UNITED STATES
DEPARTMENT OF THE INTERIOR
BUREAU OF LAND MANAGEMENTFORM APPROVED
OMB NO. 1004-0137
Expires: January 31, 2018**SUNDRY NOTICES AND REPORTS ON WELLS**
Do not use this form for proposals to drill or to re-enter an abandoned well. Use form 3160-3 (APD) for such proposals.5. Lease Serial No.
NMLC061705B

****MULTIPLE WELLS****

BOP Break Testing Variance

Subject: Request for a Variance Allowing break Testing of the Blowout Preventer Equipment (BOPE)

Note: Picture below highlights BOP components that will be tested during batch operations

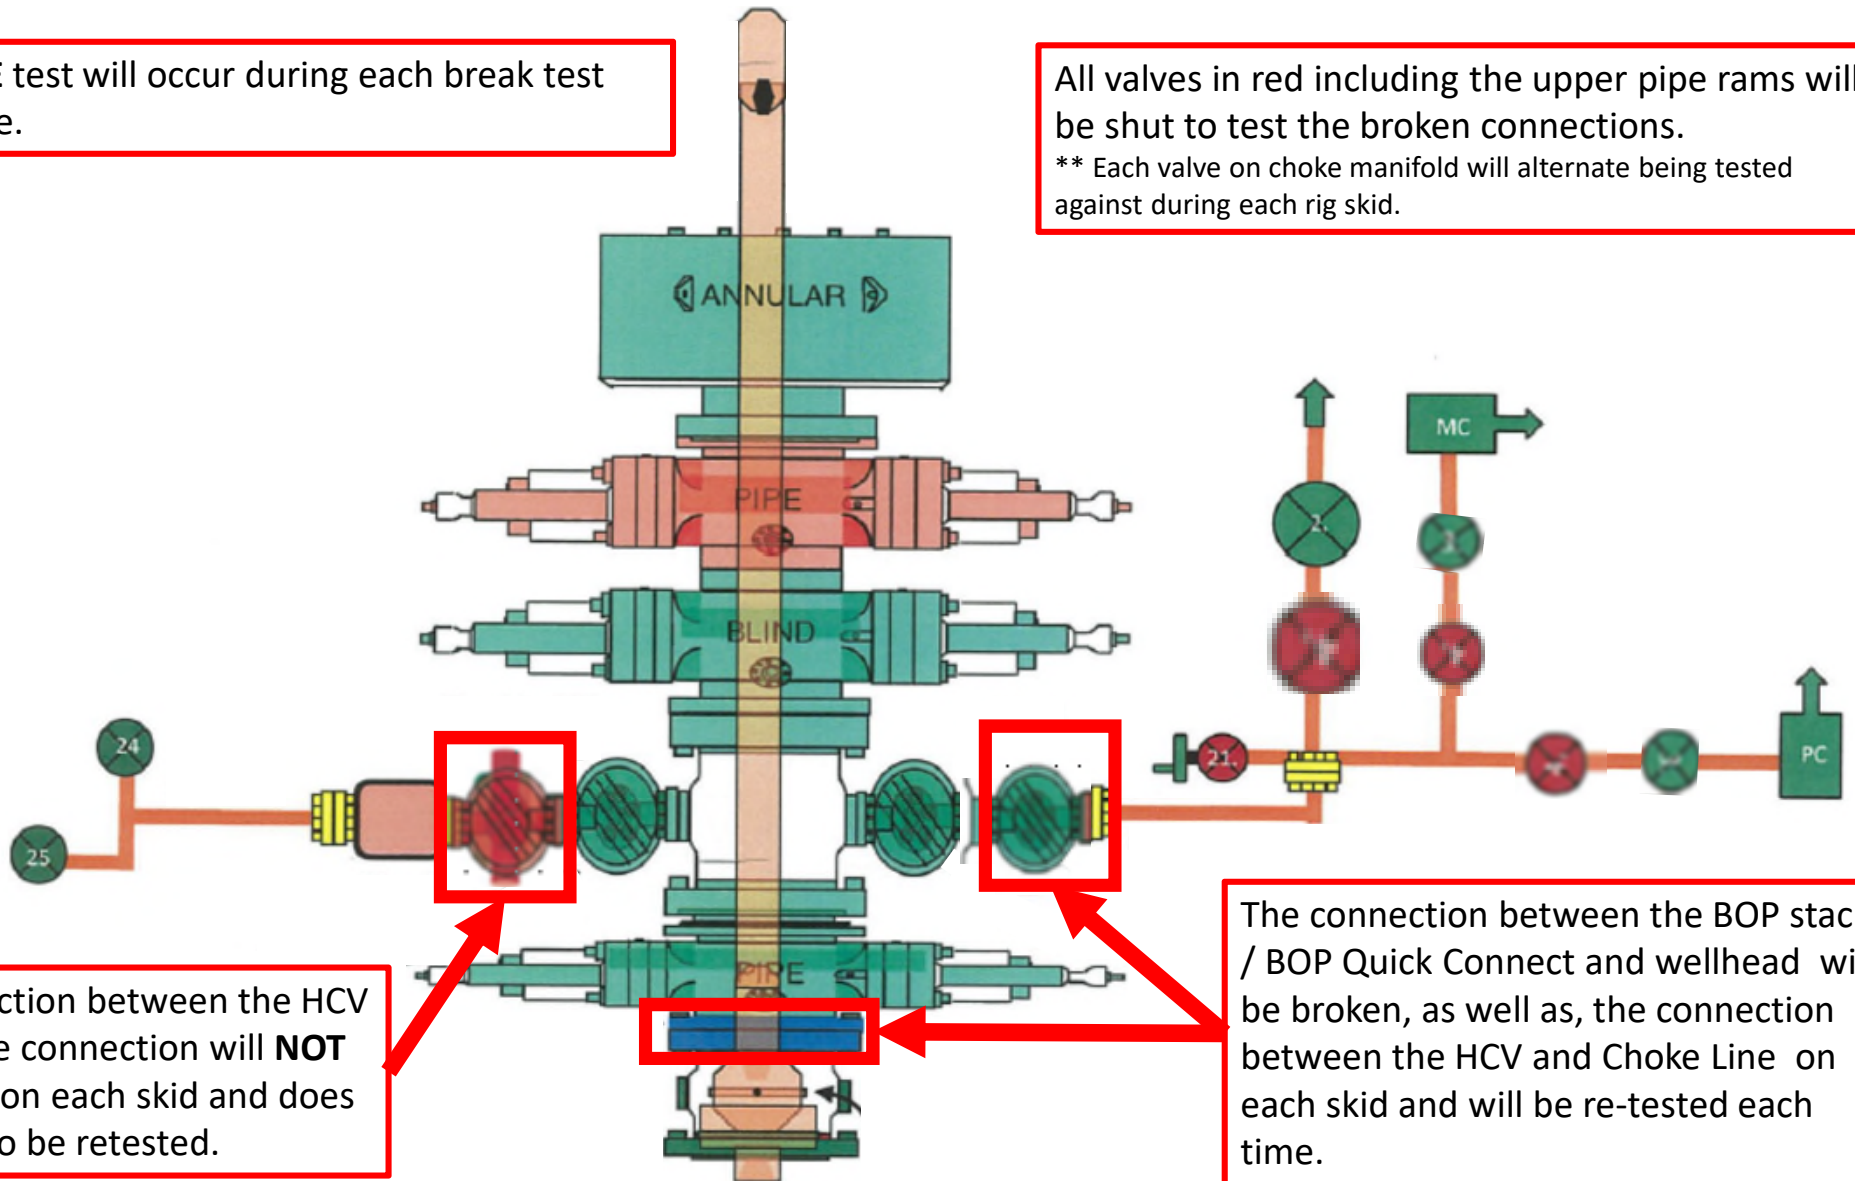
- Shell testing is not approved for any portion of the hole with a MASP of 5000 psi or greater.
- While in transfer between wells, the BOPE shall be secured by the hydraulic carrier or cradle.
- Any well control event while drilling require notification to the BLM Petroleum Engineer prior to the commencement of any BOP Break Testing operations.
- A full BOP test is required prior to drilling the first deep intermediate hole section. If any subsequent hole interval is deeper than the first, a full BOP test will be required.

All valves in red including the upper pipe rams will be shut to test the broken connections.
** Each valve on choke manifold will alternate being tested against during each rig skid.

The connection between the HCV and kill line connection will **NOT** be broken on each skid and does not need to be retested.

The connection between the BOP stack / BOP Quick Connect and wellhead will be broken, as well as, the connection between the HCV and Choke Line on each skid and will be re-tested each time.
